# ELM LAKE DAM

PHASE I INSPECTION REPORT  
NATIONAL DAM INSPECTION PROGRAM

NDI - PA 00397  
PA DER 52 - 164

DEPARTMENT OF THE ARMY  
BALTIMORE DISTRICT, CORPS OF ENGINEERS  
BALTIMORE, MARYLAND 21203

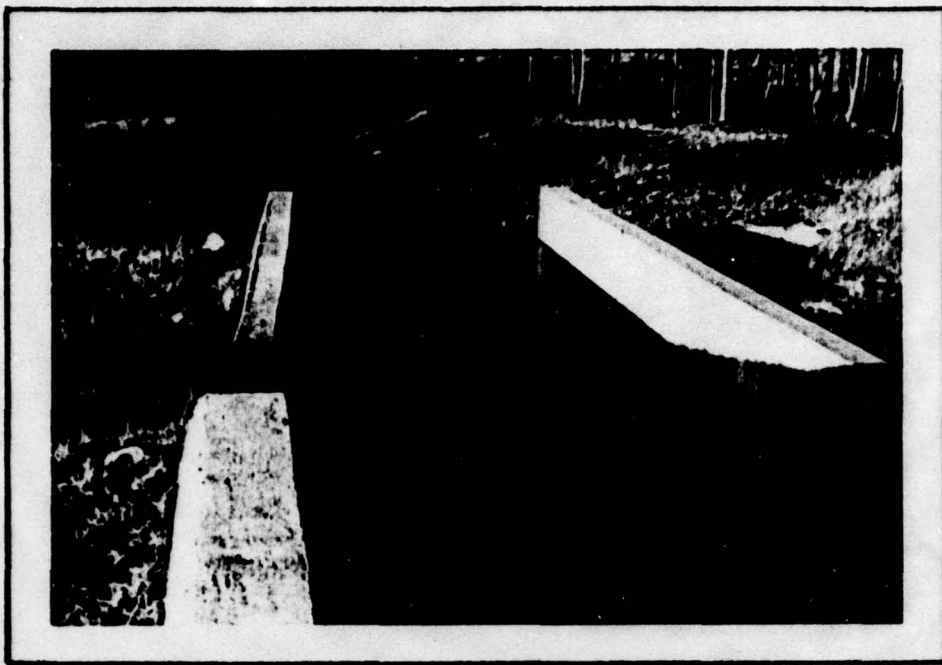
*UPSTREAM FACE OF DAM  
LOOKING TOWARDS RIGHT ABUTMENT*

*SPILLWAY AND OUTLET CHANNEL  
LOOKING FROM SPILLWAY CREST*

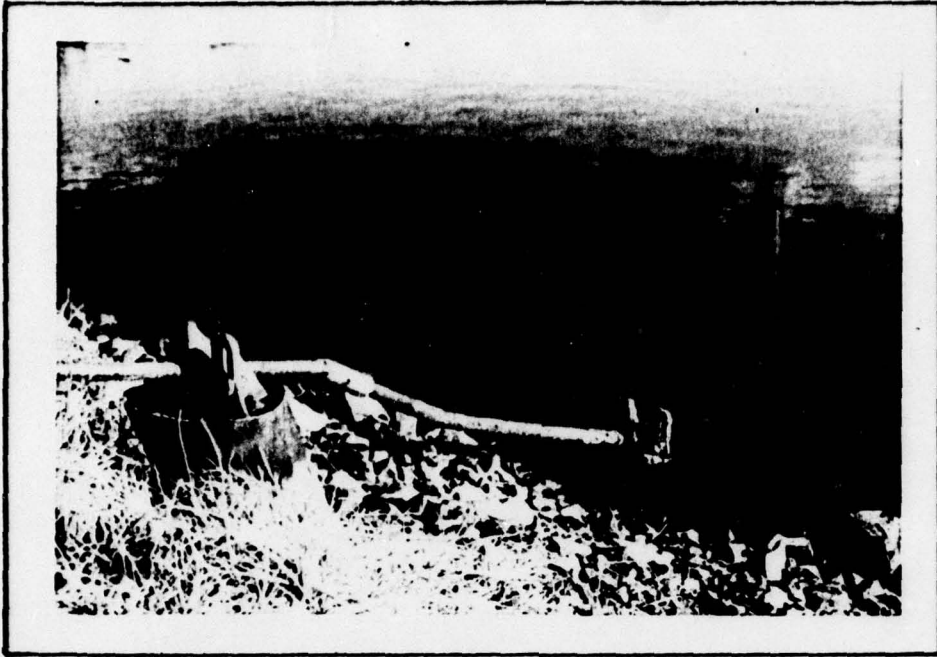
*MARSHY REGION WHICH STARTS  
ABOUT 100 YARDS DOWNSTREAM OF THE DAM*

*POORLY MAINTAINED HOIST STEM  
OF THE RESERVOIR DRAIN SYSTEM*

*PARTIALLY BURIED RESERVOIR  
DRAIN OUTLET STRUCTURE*

1. Immediate repairs should be made on the reservoir drain system to provide for reservoir draw down. The outlet structure should be cleared of mud and debris to allow free flow from the outlet pipe.

**PLATE 5**  
Profile of Top  
of Dam

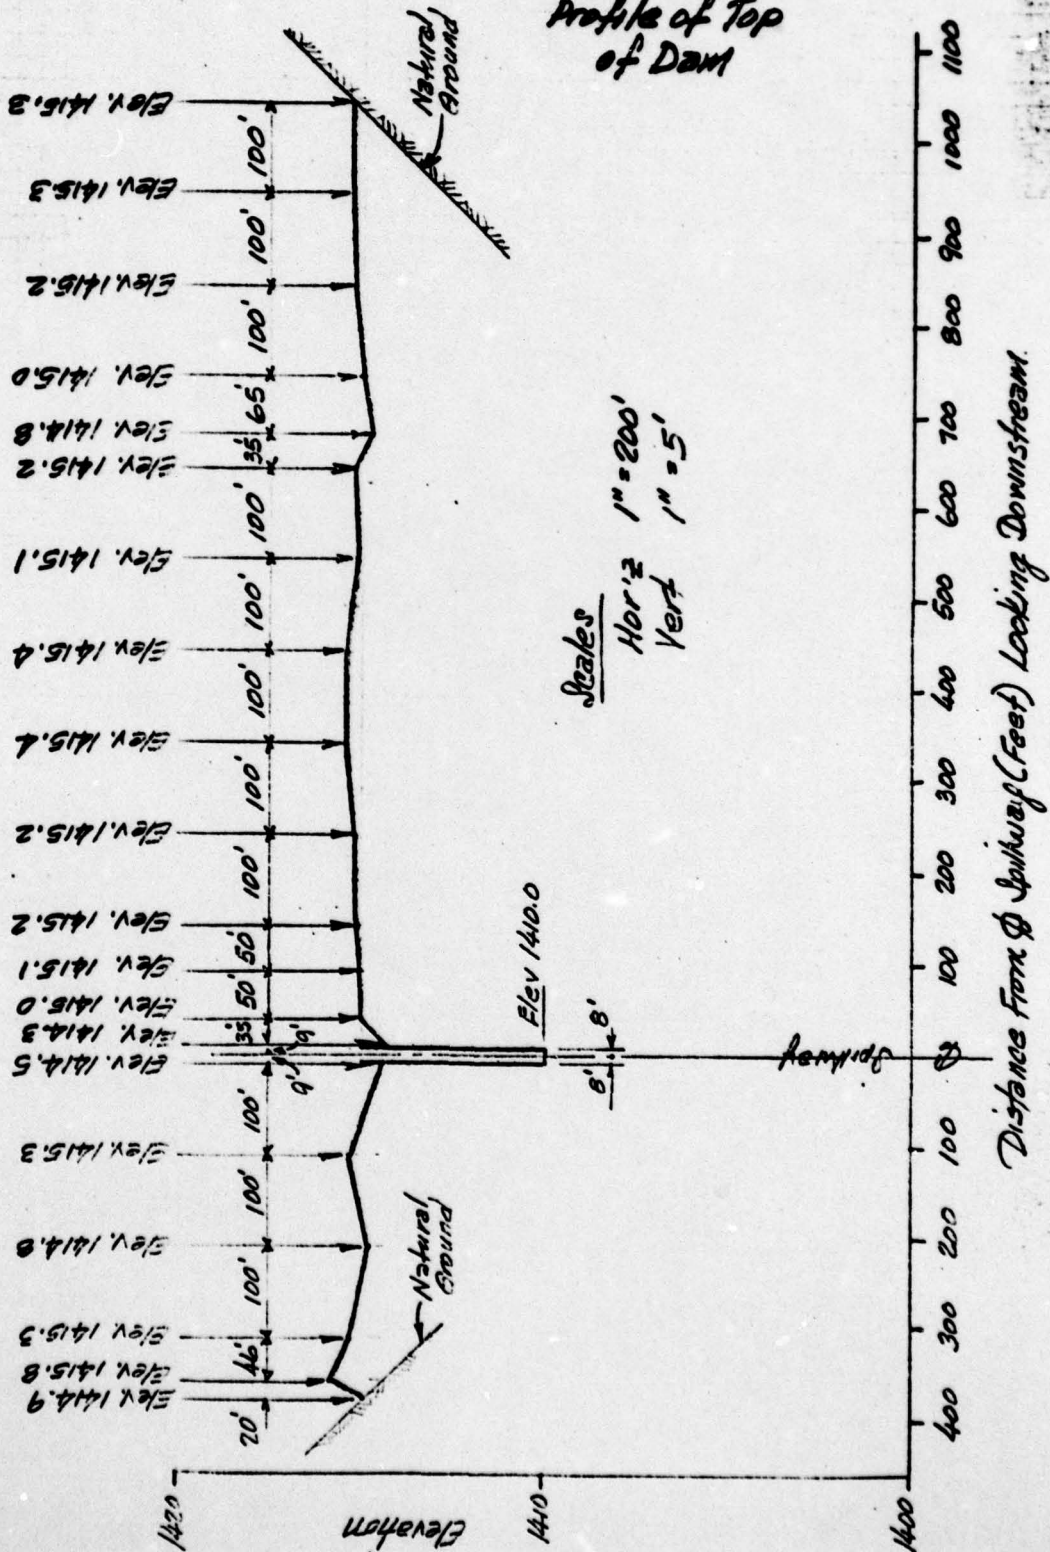
b. Dam. There are numerous bulges, and depressions which form an undulating pattern along both the upstream and downstream slopes and the top of the dam. A survey revealed that the top of the dam elevation varies as much as 1.5 feet along the length of the embankment. The riprap facing varies in gradation and thickness. Predominantly large rocks have been dumped in some areas, small stones in other areas, and no cover at all in still other areas. The grass cover on the embankment slopes is sparse; there is virtually no grass cover along the top of the dam. There is a large area of standing water between the reservoir drain outlet and the right abutment just downstream of the toe.

3. The top of the dam should be raised to the design top of the dam elevation in any areas that are below grade to prevent overtopping at stages less than maximum pool.
